COPPERSTRING EIS

Attachment F - Vegetation Clearing Works plans

Selwyn Substation to Woodya Substation

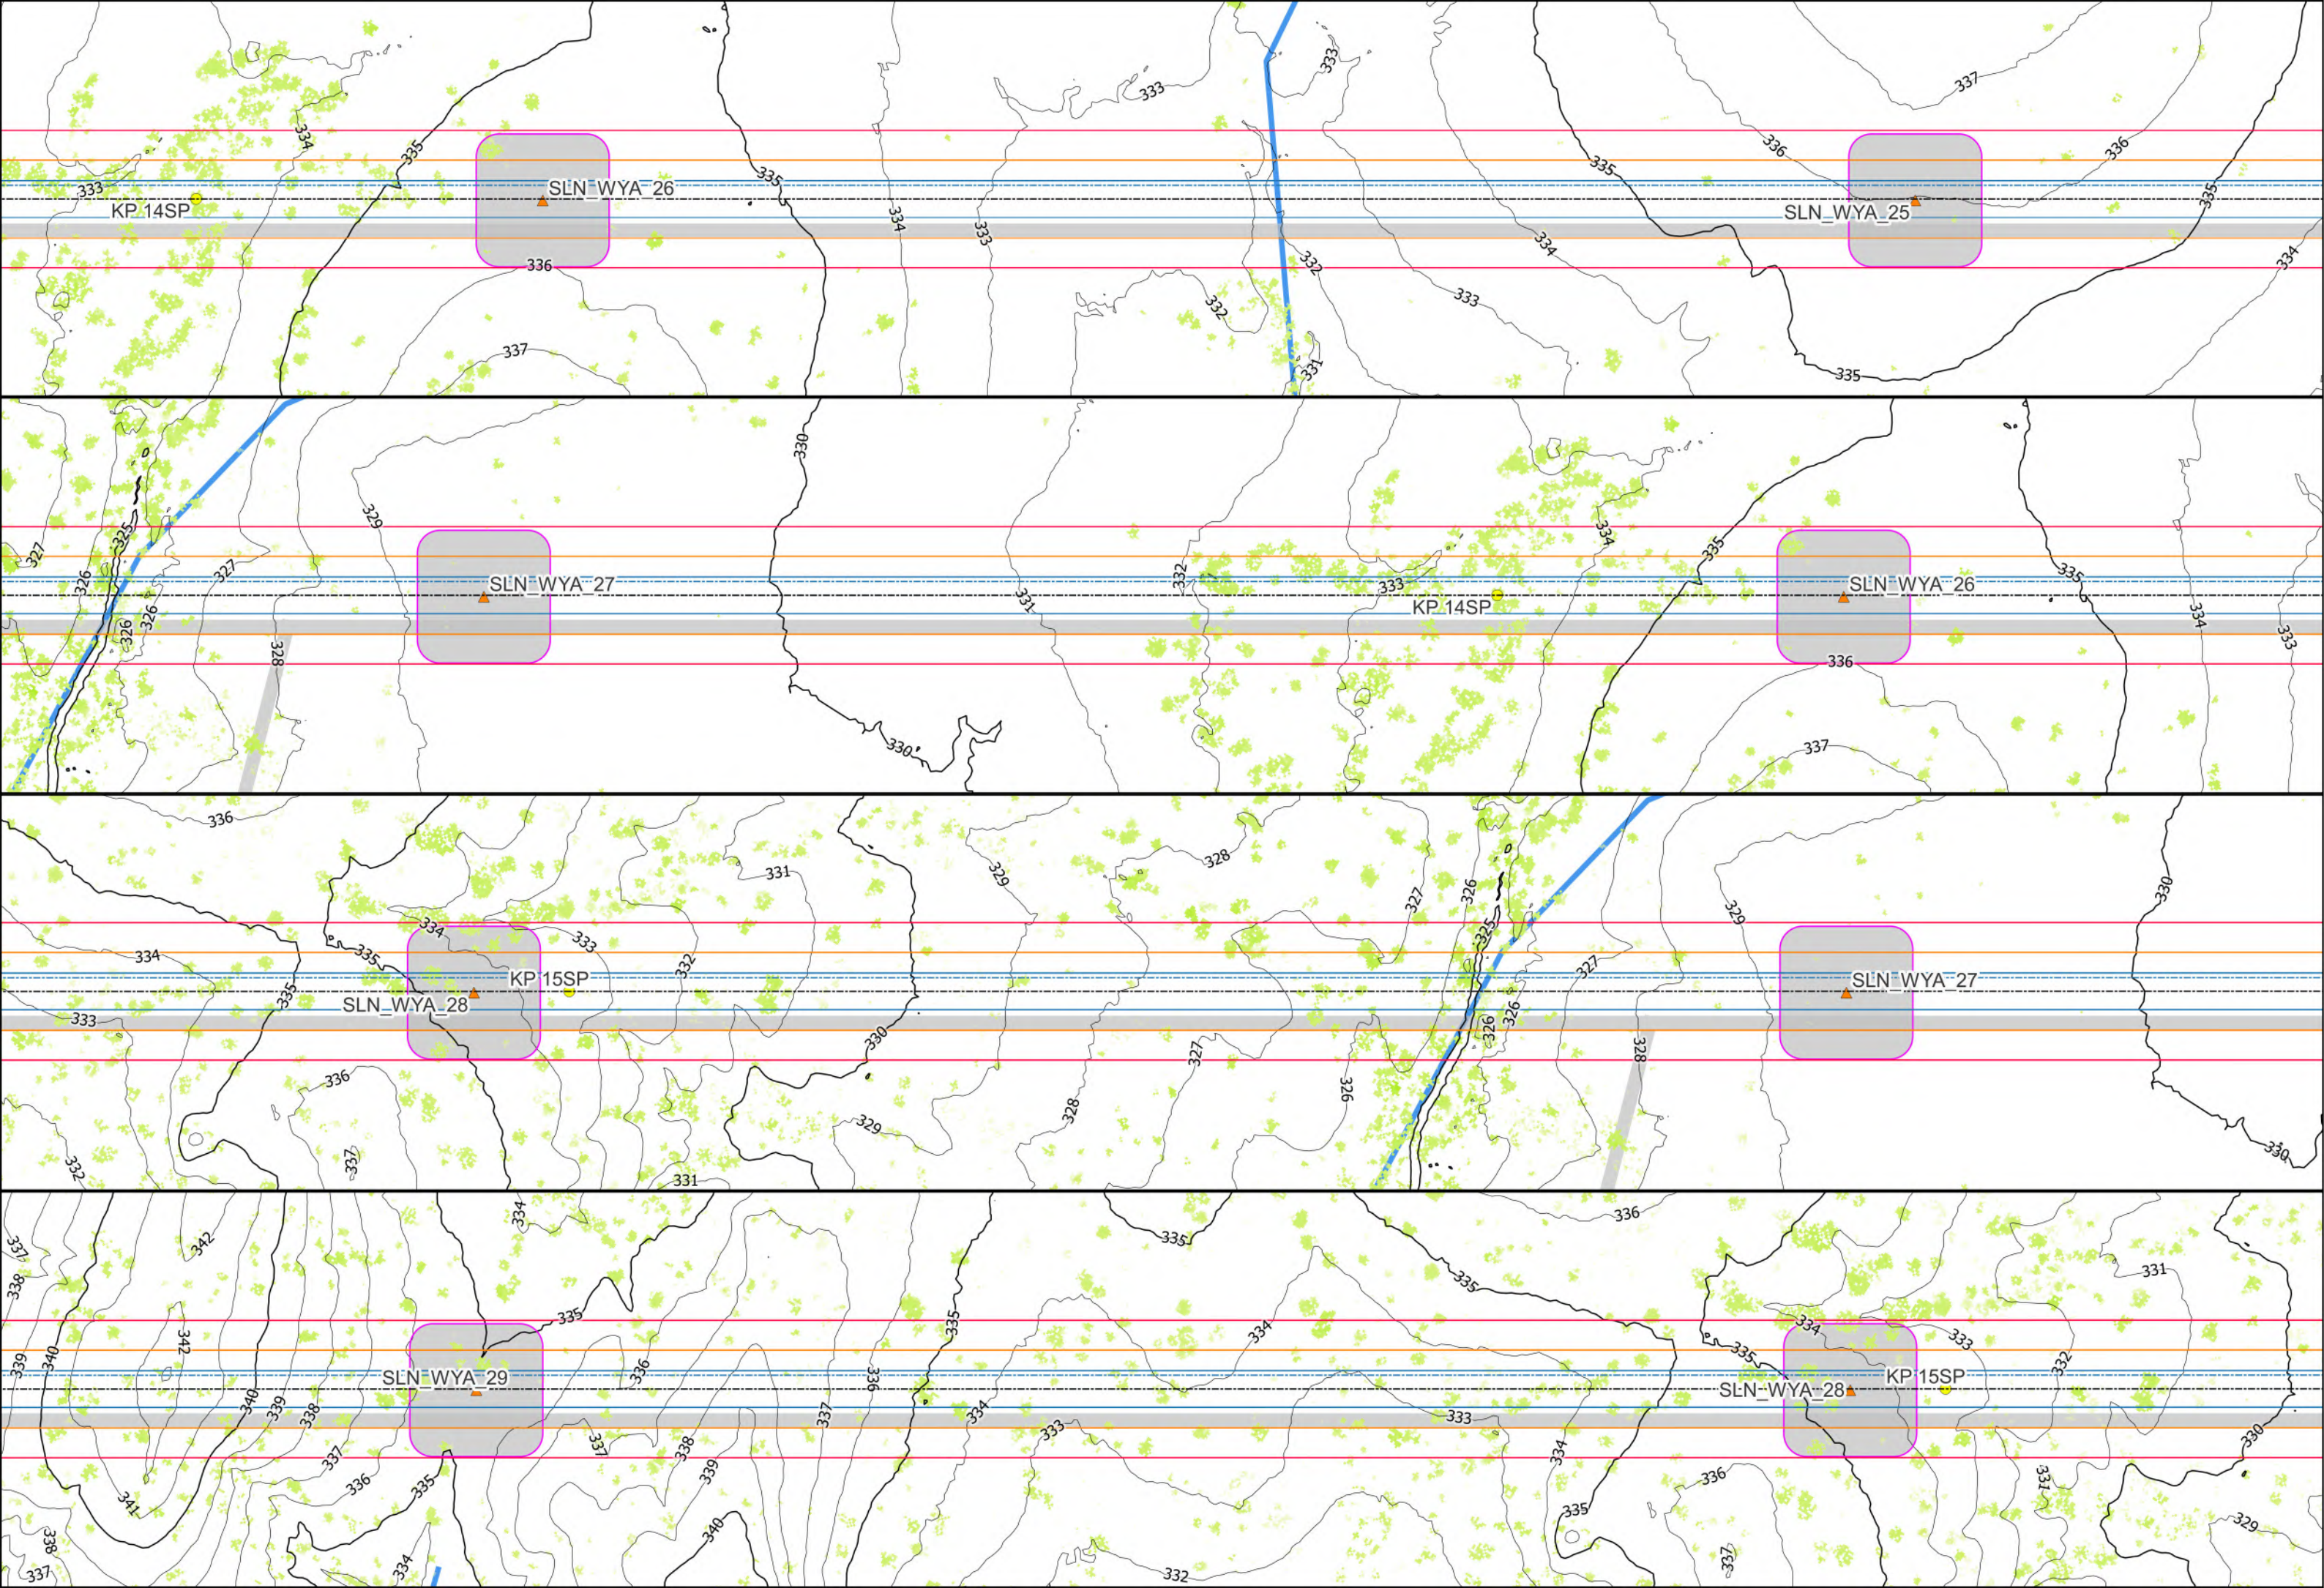
Tower assembly area to be reconfigured to not be within 15m of the high bank of waterway and to avoid clearing near or within the bed and banks for the waterway.

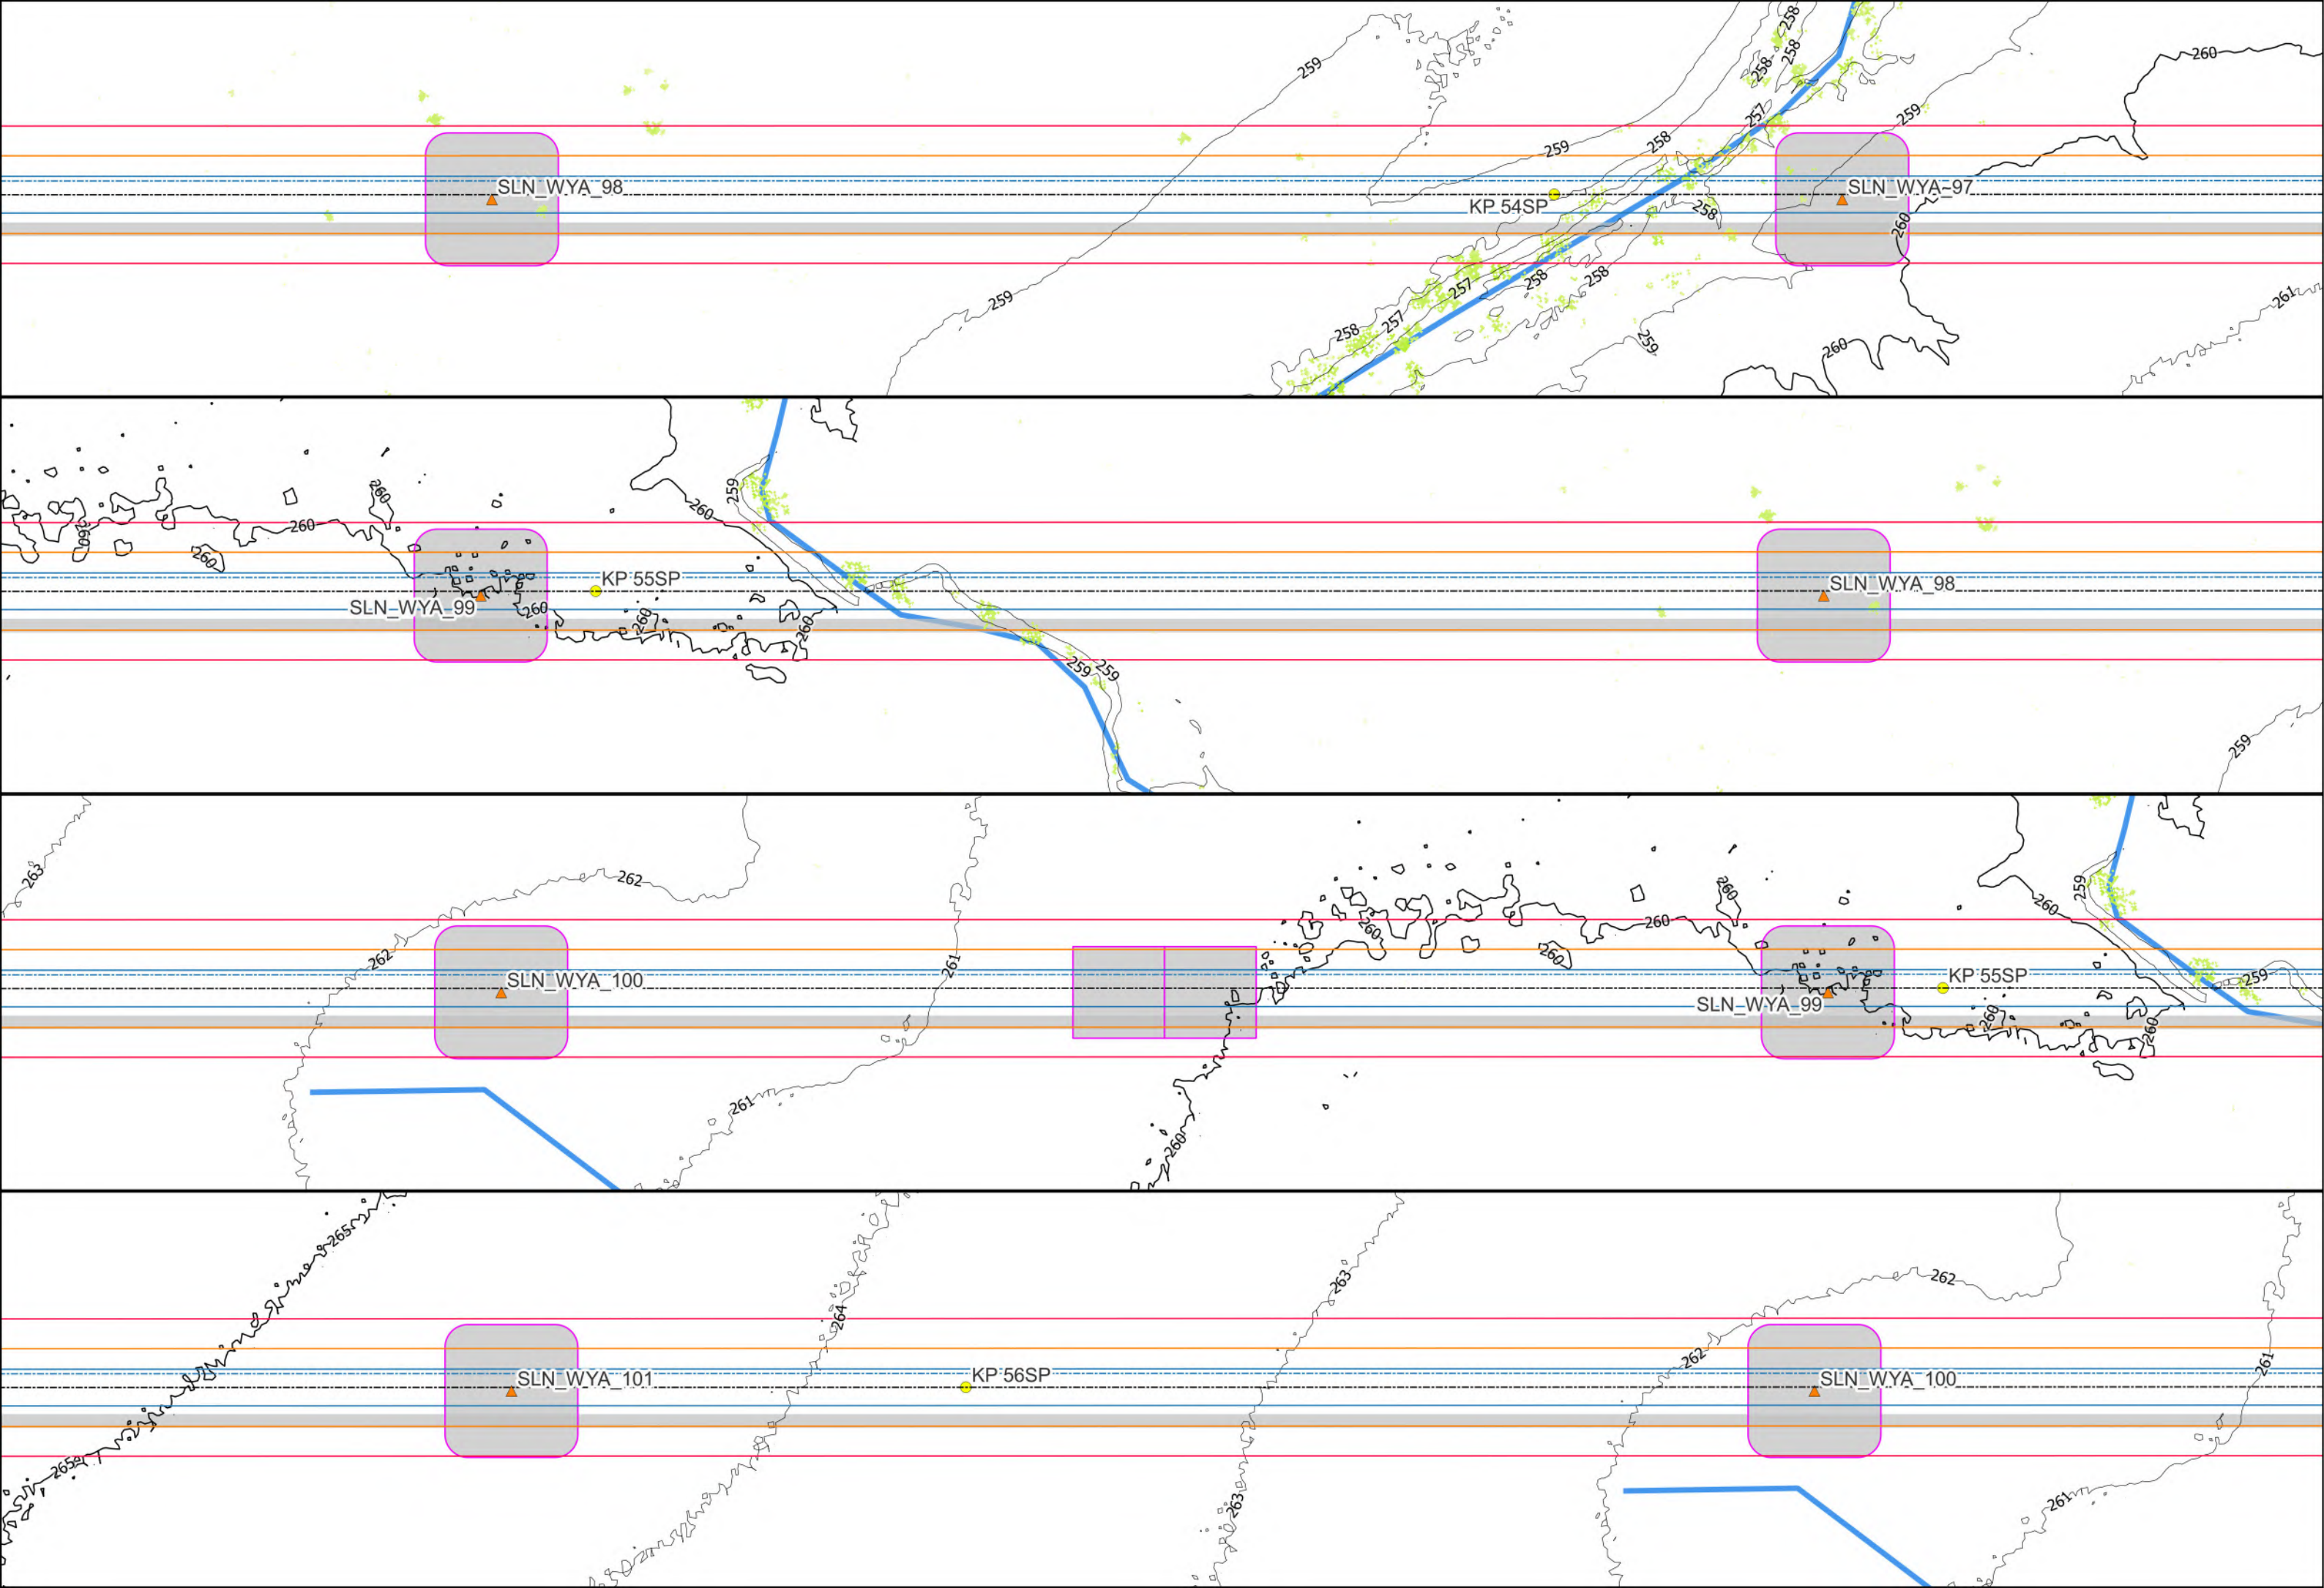
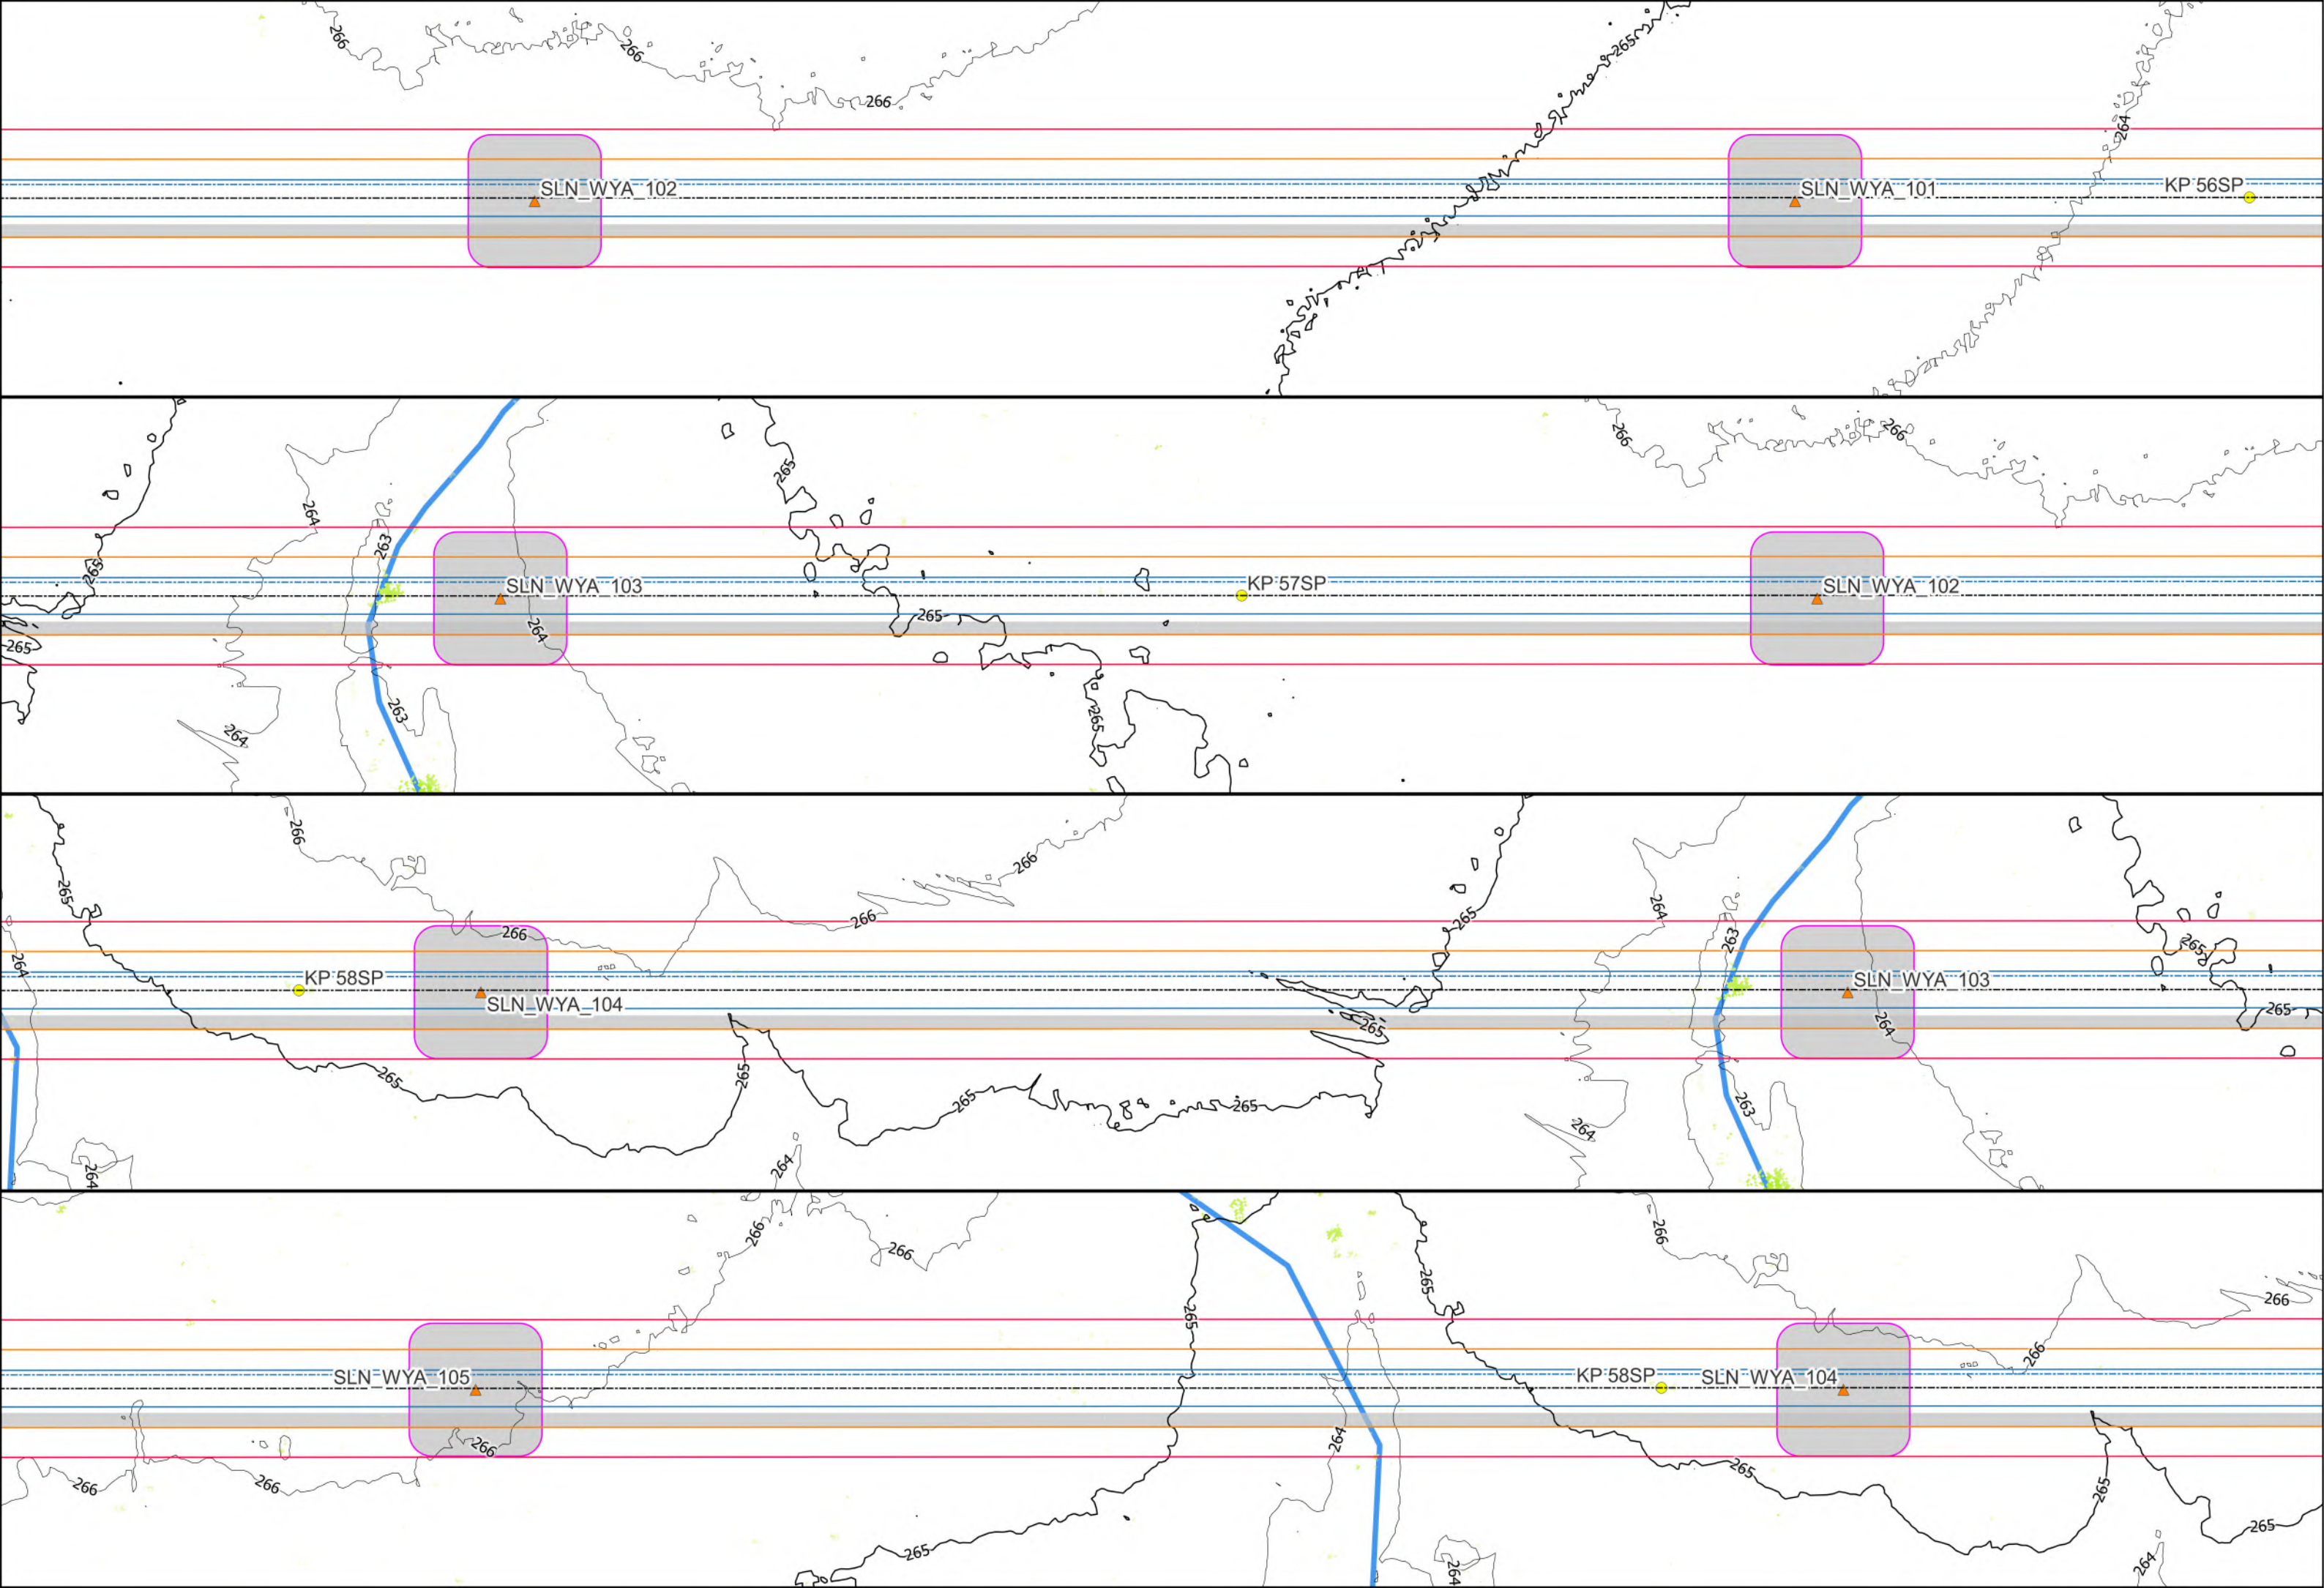
Tower assembly area to be reconfigured to not be within 15m of the high bank of waterway and to avoid clearing near or within the bed and banks for the waterway.

Tower assembly area to be reconfigured to not be within 15m of the high bank of waterway and to avoid clearing near or within the bed and banks for the waterway.
